MELROSE PARK SOUTH-WEST BLOCK B2 & B3

Design Report – State Significant Development Application (SSD-71558711)
Response to DPHI Issues Letter

Prepared for
Wharf and Hughes Developments Pty Ltd.

Issued
28 November 2025

2.8 Bicycle Parking/End of Trip Facilities

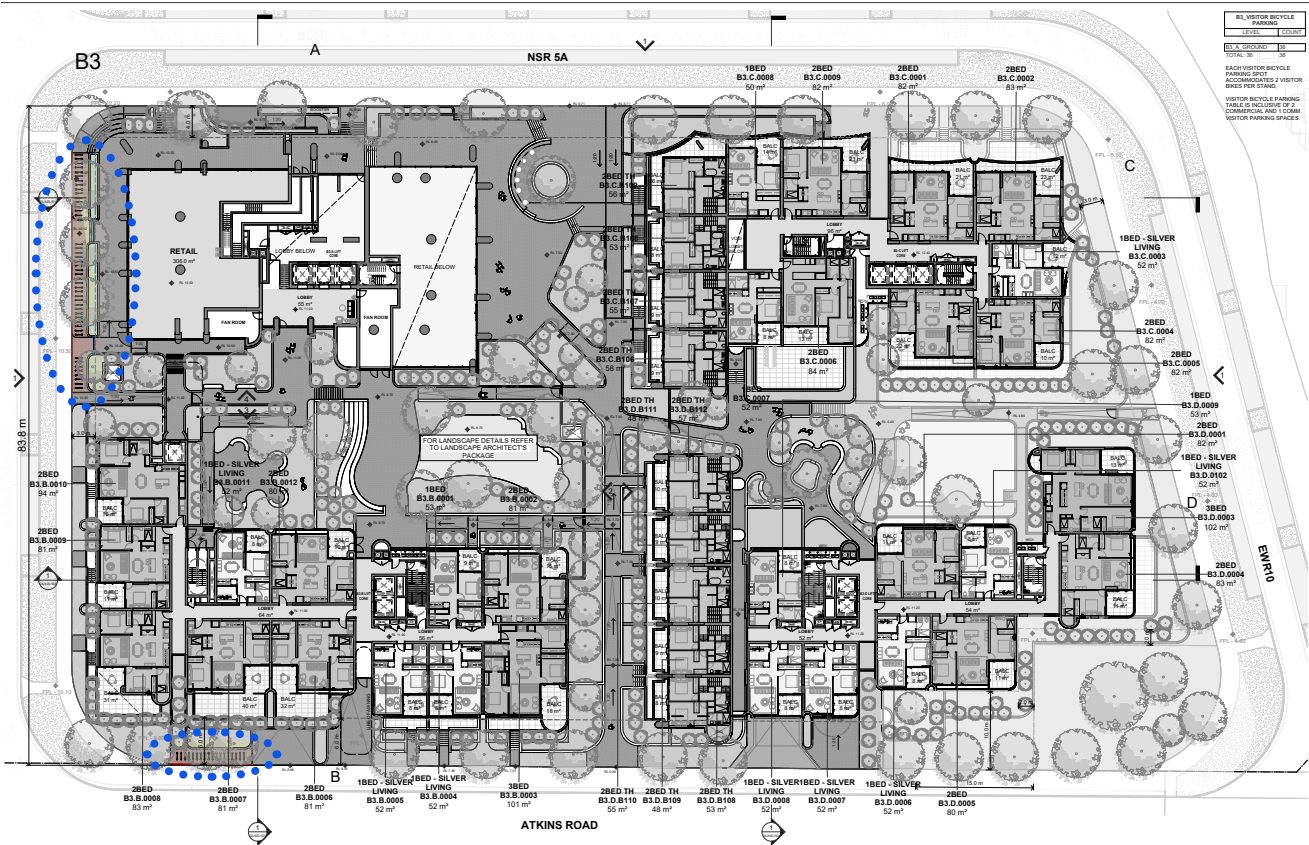
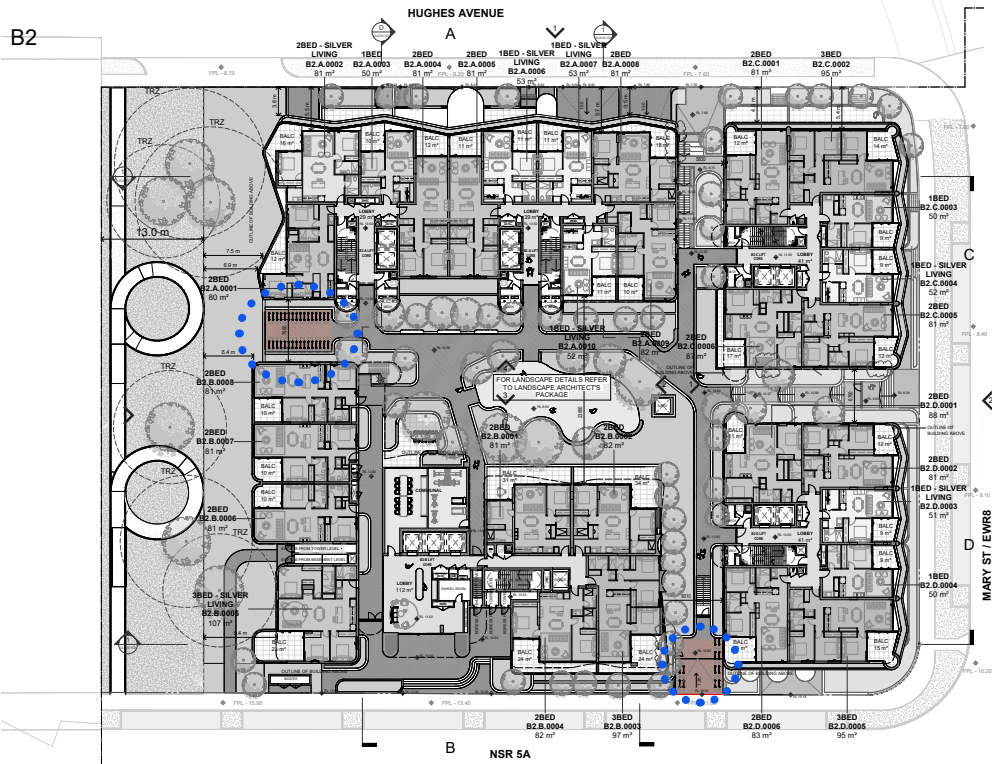
- Review the location of residential visitor bicycle parking to ensure they are located as close to ground level as possible within of each block.
- Provide end-of-trip facilities within Block B3, noting these should form part of the current proposal, not as part of a future tenancy fitout development application given multiple tenancies are proposed.

- Where possible, residential visitor bicycle parking have been located as close to the ground level as possible within each block.

B3

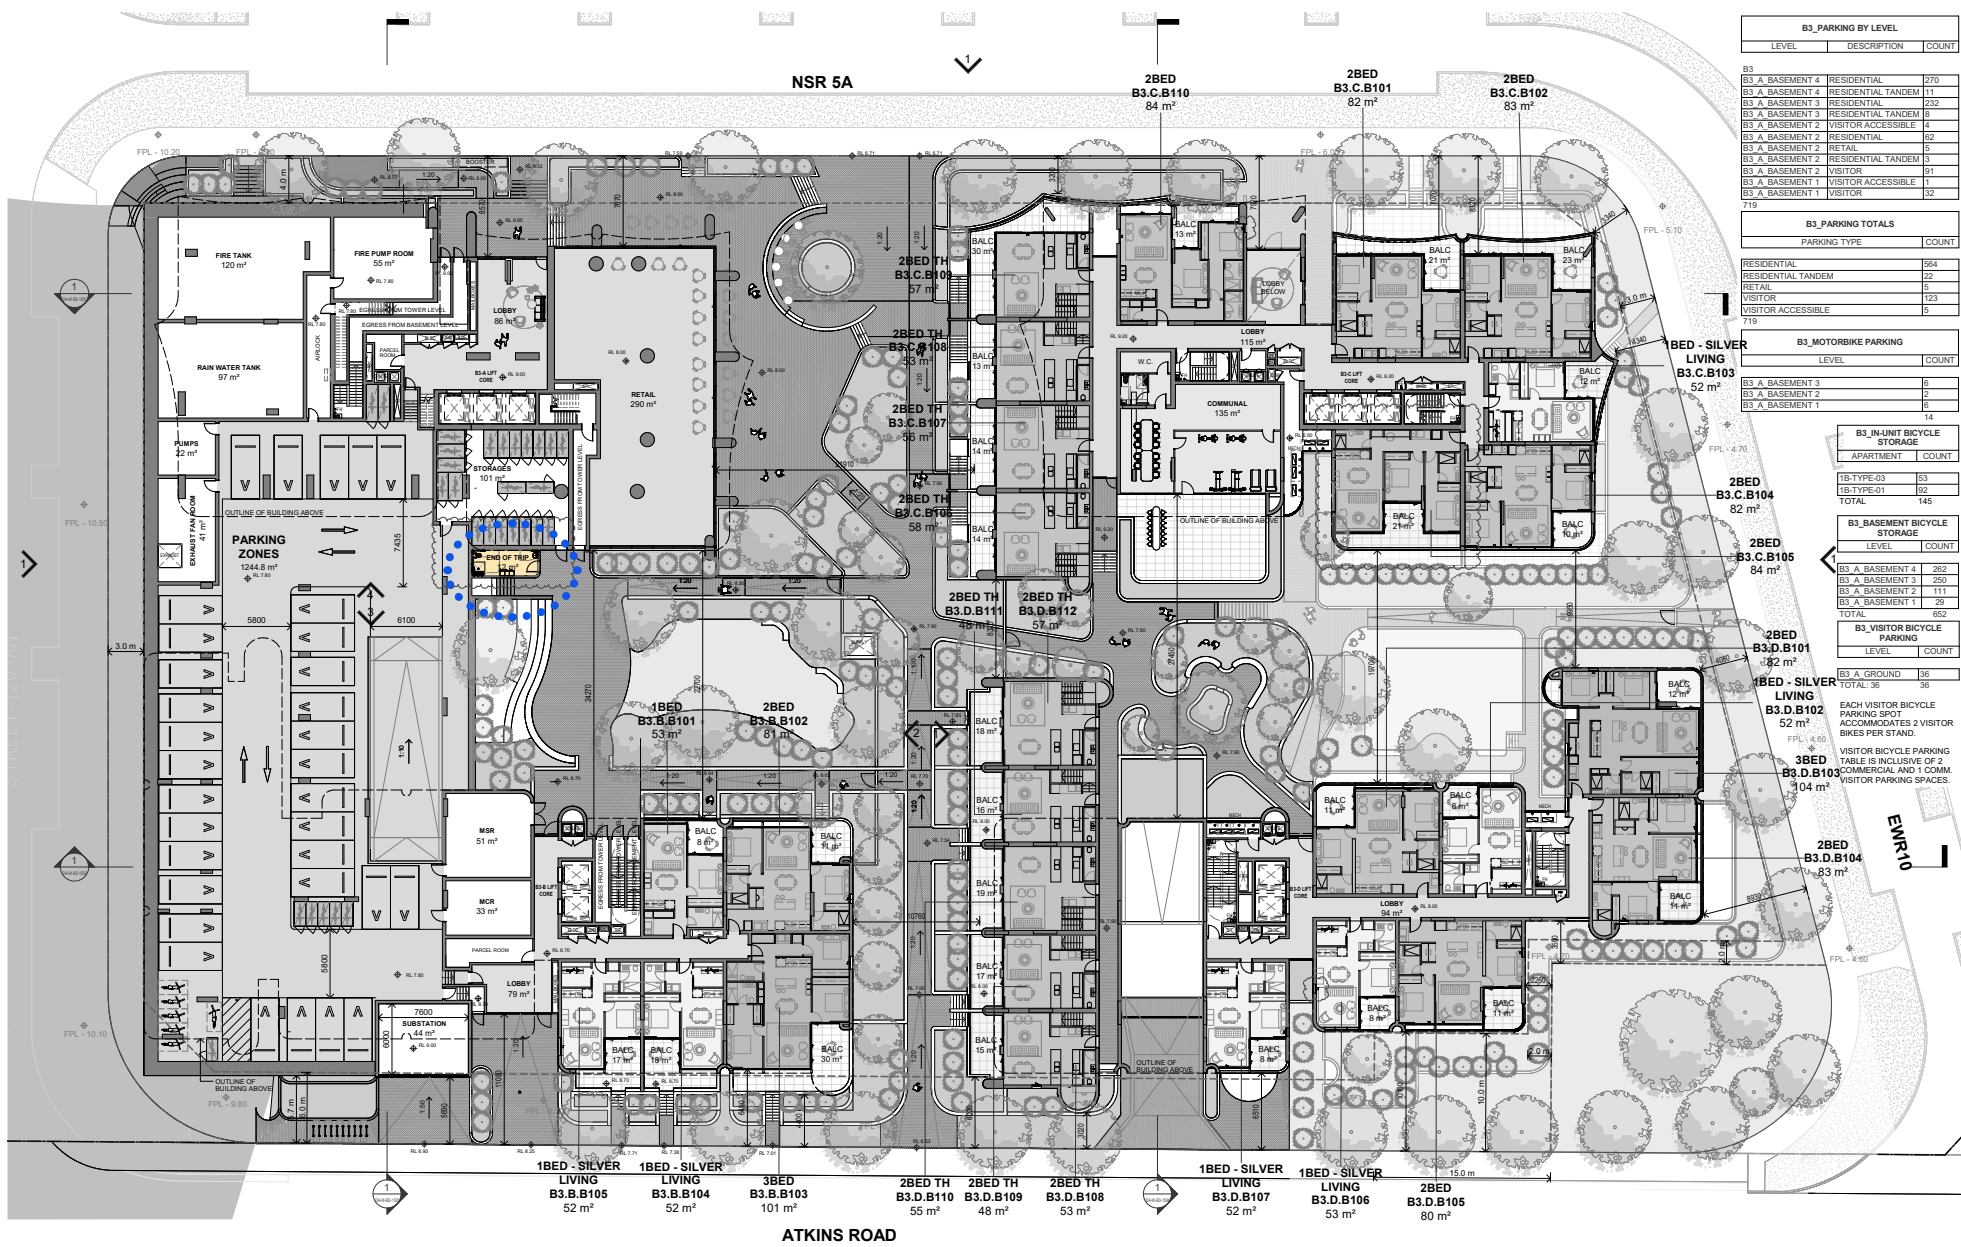
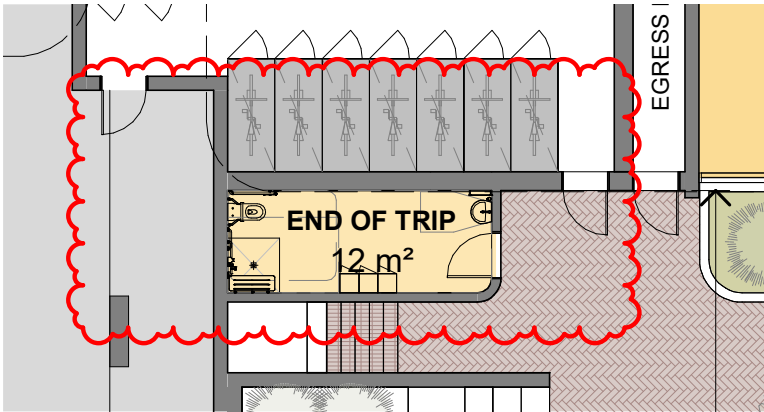
- Review the location of residential visitor bicycle parking to ensure they are located as close to ground level as possible within each block.
- Provide end-of-trip facilities within Block B3, noting these should form part of the current proposal, not as part of a future tenancy fitout development application given multiple tenancies are proposed.

- End of trip facility has been added within block 3, with easy access to courtyard, retail and carpark. The facility includes an accessible shower, basin, toilet and locker facilities.

3.2 Car Park Design and Urban Design

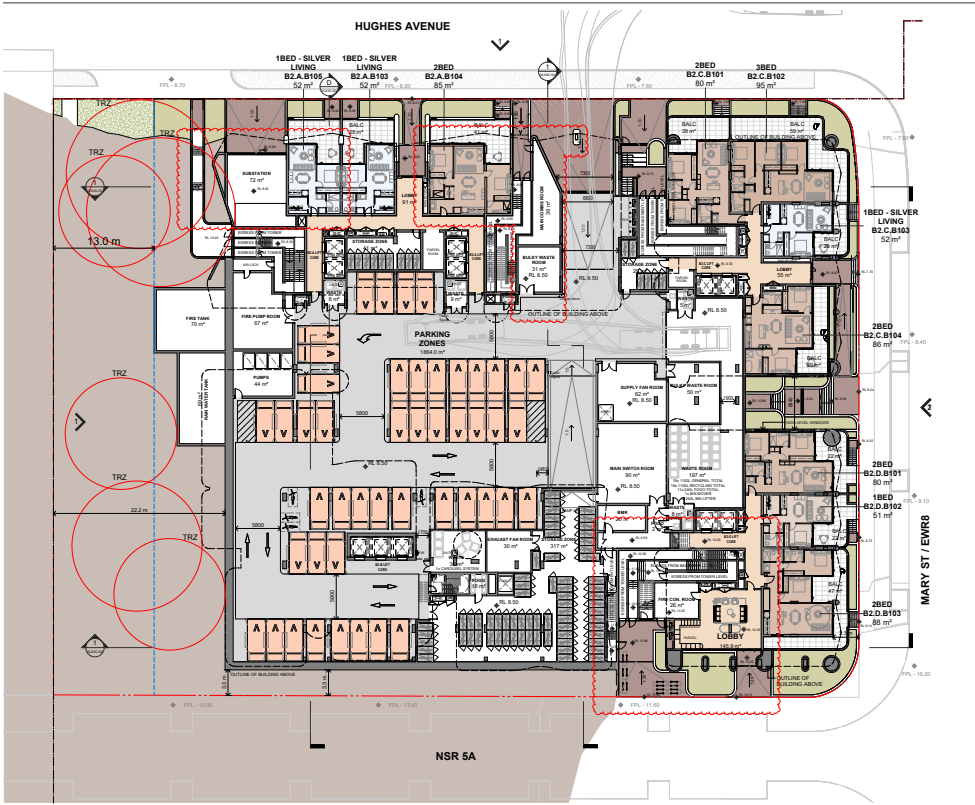
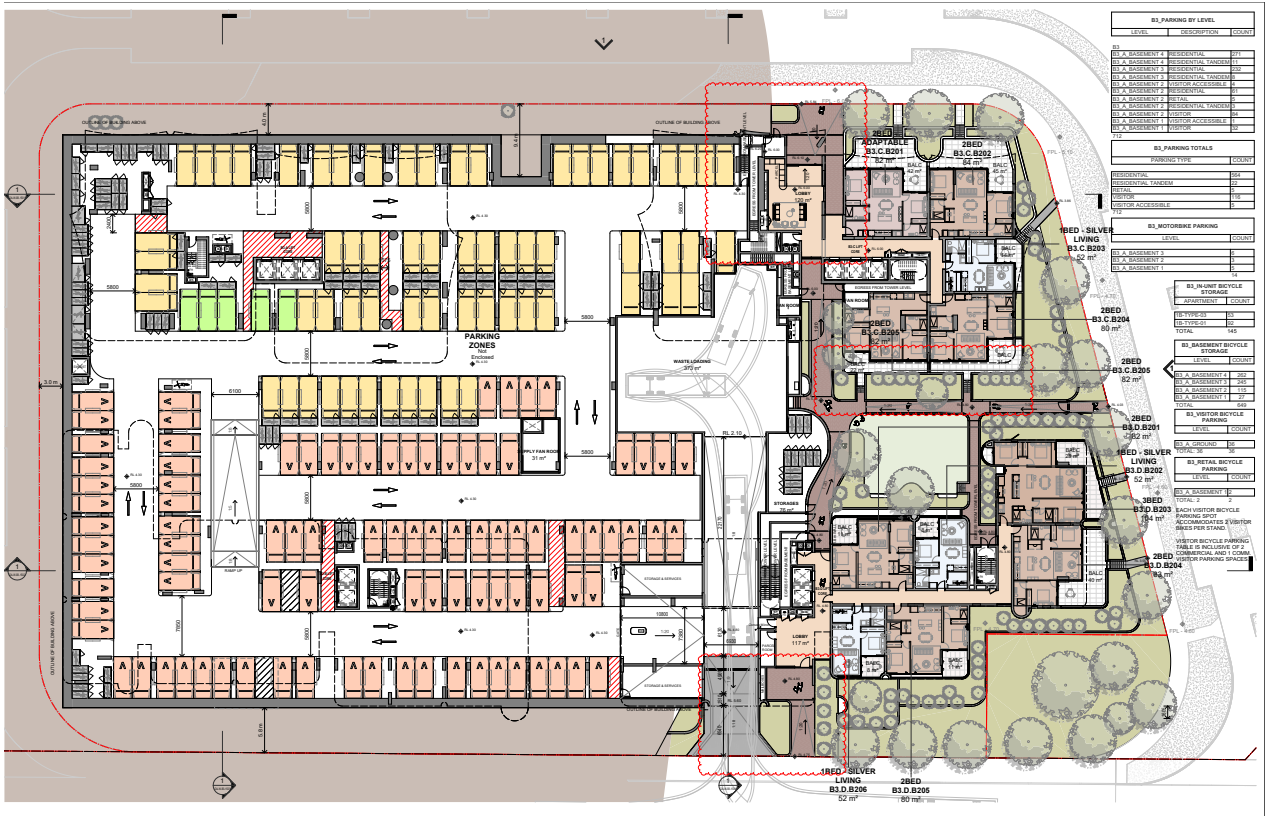
- The location of the control point into the basement car park is not shown. The control point must comply with the requirements of the Australian Standards and must ensure that no vehicles are obstructing the road reserve including the footpath. Swept paths for loading vehicles will also need to be checked to ensure service vehicles will be able to travel around any intercom/card reader if being used. An updated TIS should be required to perform this assessment.

- At the end of a blind aisle (top left of the page on BL2-4), there are two parking spaces that are parallel to the direction of vehicle travel. Access out of these spaces is likely not going to be possible without excess manoeuvres or long reversing manoeuvres. Accordingly, these spaces are to be removed.

- Both Blocks have a significant number of individual unit entries off the street or publicly accessible areas. Individual ground level entries are supported as a way of integrating a large development more intimately with the public domain. Council would encourage the inclusion of more entry points, particularly for Block B2. However, all entries should align to an appropriately placed architectural threshold for the corresponding Unit. Simply having a connection into the POS of a unit will not provide the integration of building to street, instead it risks being perceived as the back gate to the backyard.

- Car park entrances and layouts have been adjusted to accommodate control points.

- Parking updated.

- Additional ground floor unit entries off the street or publicly accessible areas have been added where possible.

49. Retail Tenancy Bicycle Parking

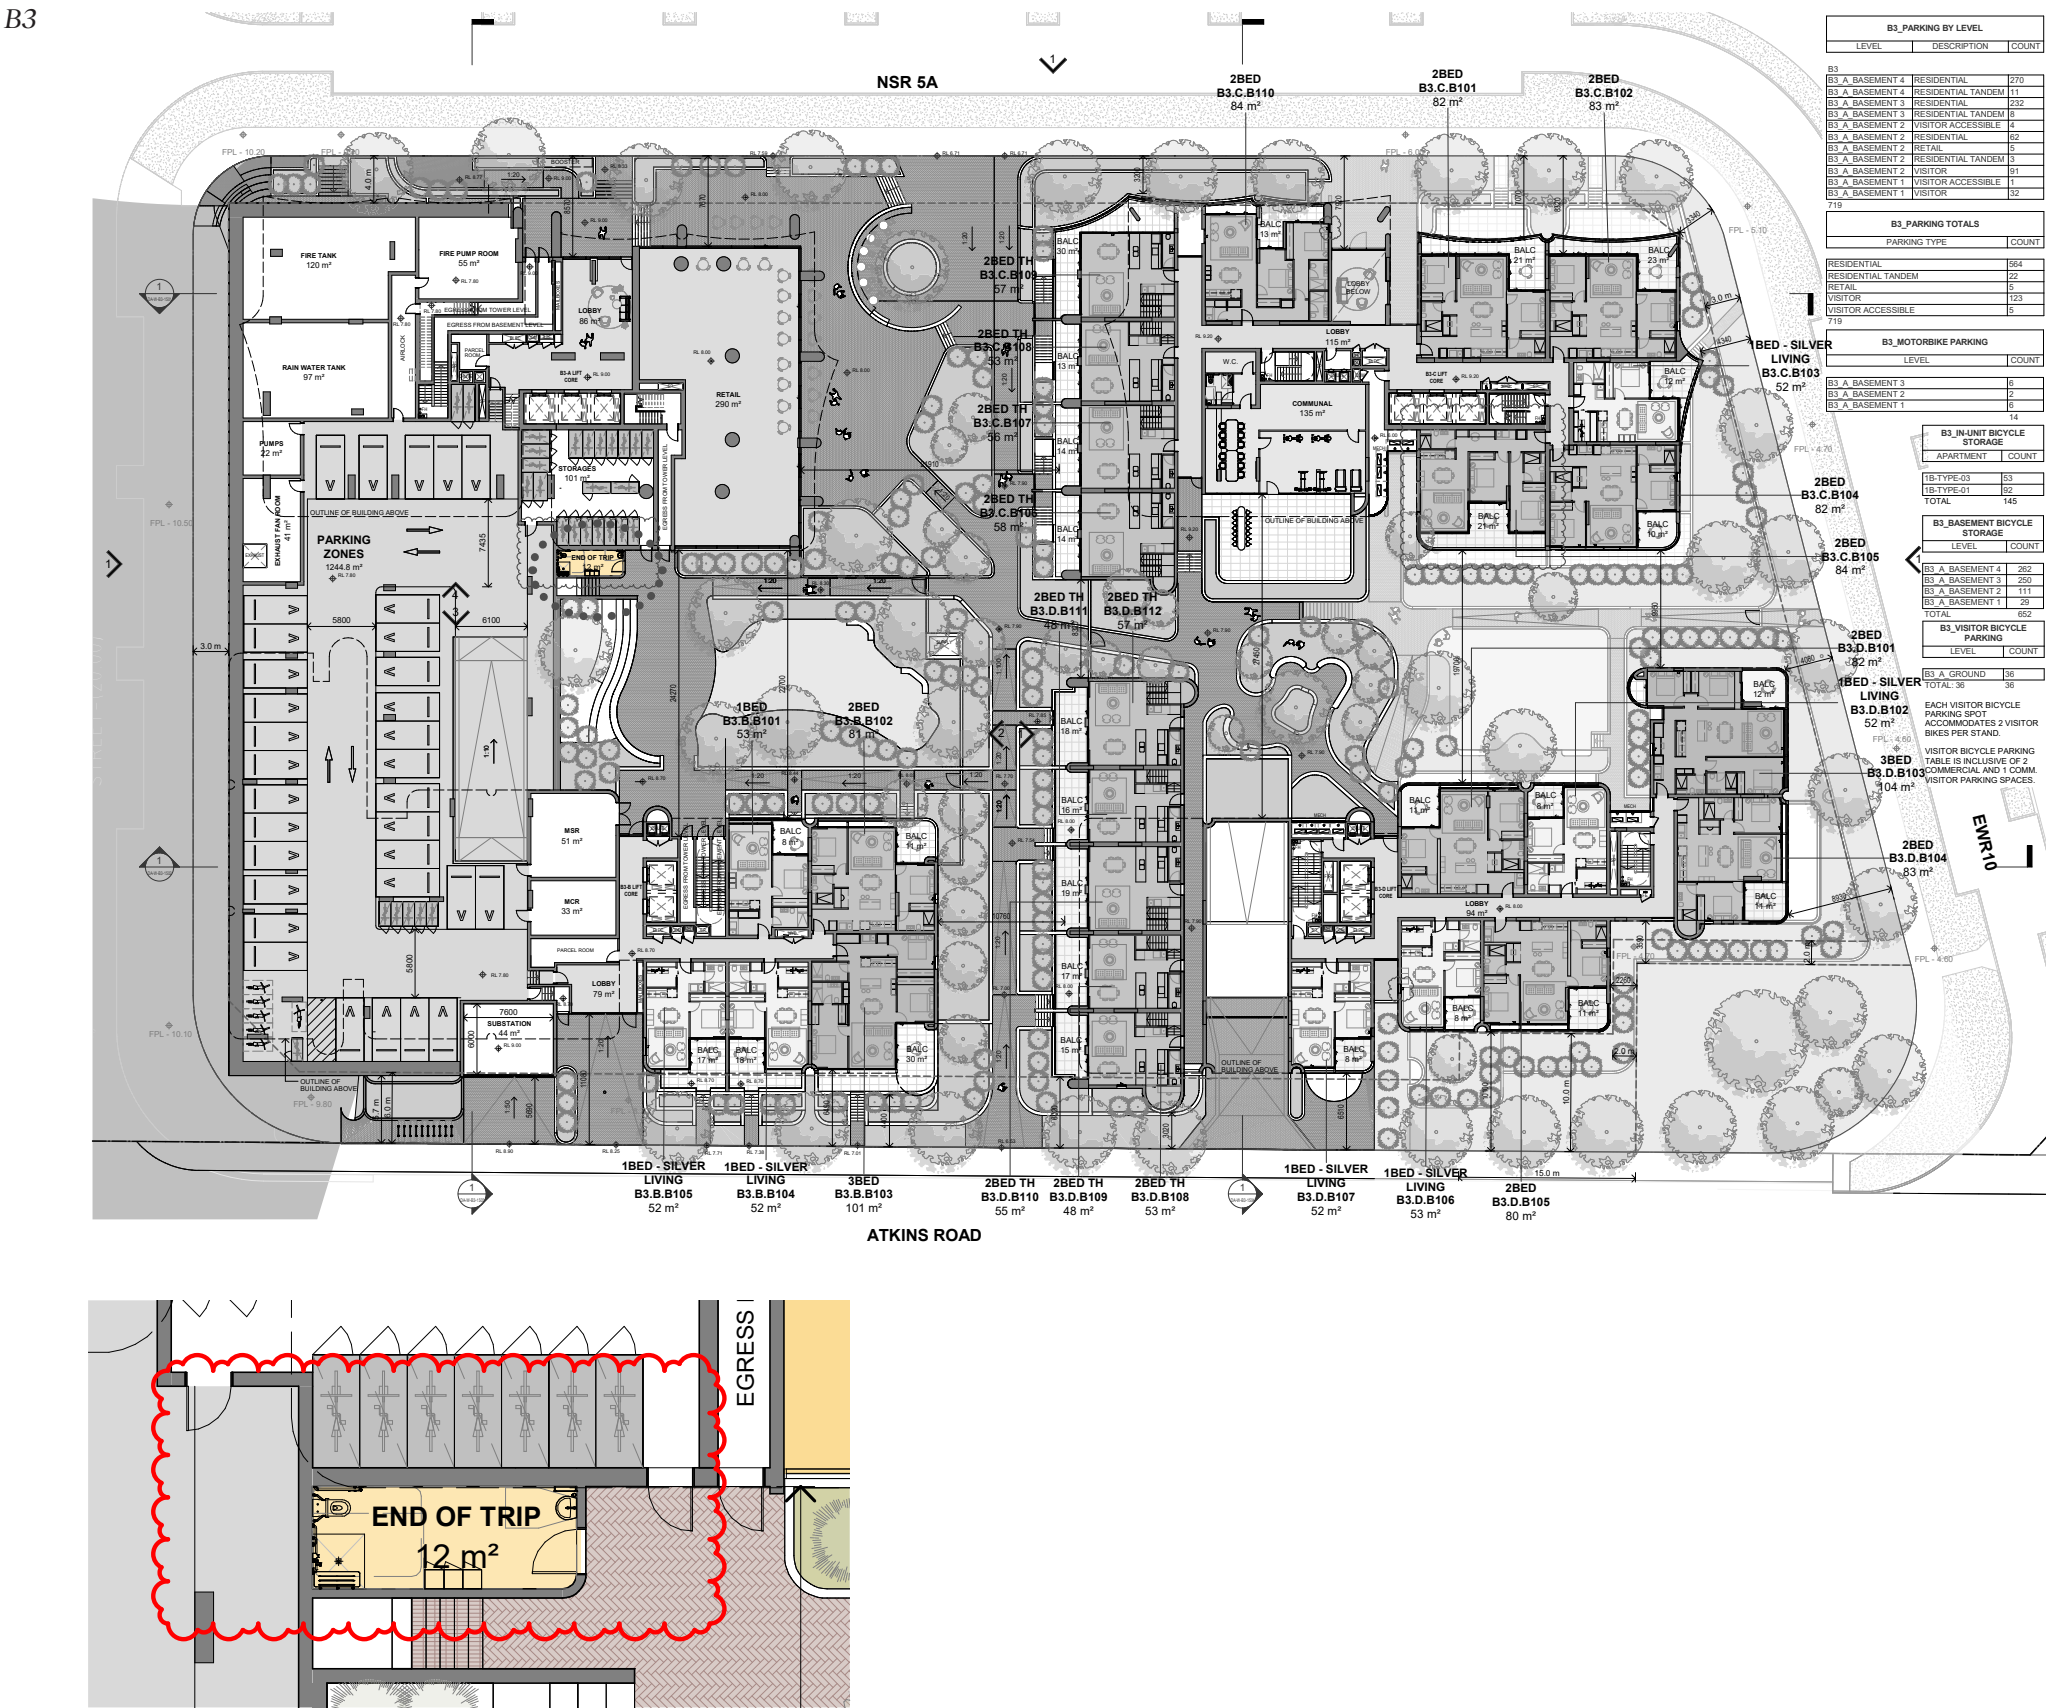
- Council requests that details on bicycle parking and end of trip facilities for the retail tenancy (1 shower and 2 personal lockers) be shown on architectural plans to avoid possible retrofitting of the building at fit-out stage.

- EOT facility has been added now to B3.
